Access Compliance Report Public Rights-of-Way (Curb Ramps)

Main Street: OLD_RANCH_RD Cross Street: BROKEN_HILL_CT Location: NW

ADA ID: RPAT210922090335 Ramp Type: Type 3 - Combination 1 Initial Pass/Fail: Fail Overall Compliance: No Severity Score: 64

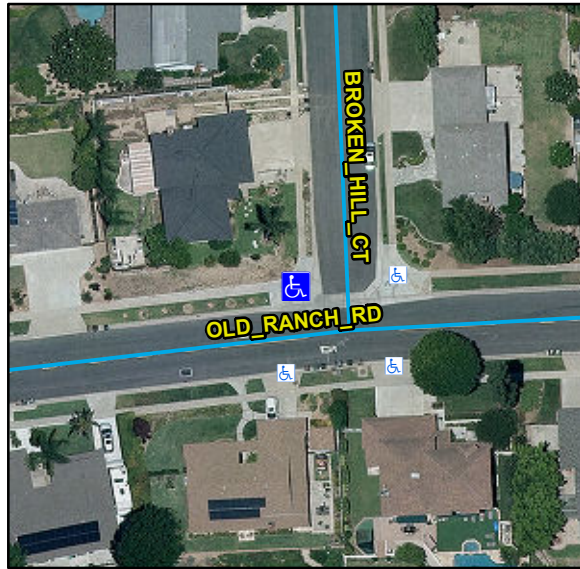
R304.2.2, R204.3, R304.5.1, R304.5.3, R304.3.2, STD 1115

Compliance	Description	Data	Compliance	Description	Data
N/A	Ramp Length LT (in)	77	N/A	Ramp Length RT (in)	148
No	Ramp Width LT (in)	44	No	Ramp Width RT (in)	38
Yes	Ramp Run Slope LT (%)	6.1	No	Ramp Run Slope RT (%)	17.1
Yes	Ramp Cross Slope LT (%)	0.6	Yes	Ramp Cross Slope RT (%)	1.4
N/A	Ramp Length (in)	54	N/A	Flare Type LT	
Yes	Ramp Width (in)	48			N/A
Yes	Ramp Run Slope (%)	7	N/A	Flare Slope LT (%)	N/A
No	Ramp Cross Slope (%)	7.3	N/A	Flare Traversable LT	N/A
N/A	Landing Present	N/A	N/A	Flare Type RT	
N/A	Landing Length (in)	N/A			N/A
N/A	Landing Width (in)	N/A	N/A	Flare Slope RT (%)	N/A
N/A	Landing Run Slope (%)	N/A	N/A	Flare Traversable RT	N/A
N/A	Landing Cross Slope (%)	N/A	N/A	DWS Provided	N/A
N/A	Landing Movement Obstructed?	N/A	N/A	DWS Contrast	N/A
	Landing Movement Type	N/A	N/A	DWS Length (in)	N/A
N/A	Landing Shared	N/A	N/A	DWS Full Width	N/A
N/A	Clear Space	Yes		DWS Offset Type	N/A
N/A	Clear Space To Crosswalk (in)	N/A	N/A	DWS Offset Left (in)	N/A

Remove & Replace Curb Ramp With Two New Directional Ramps or Equivalent.
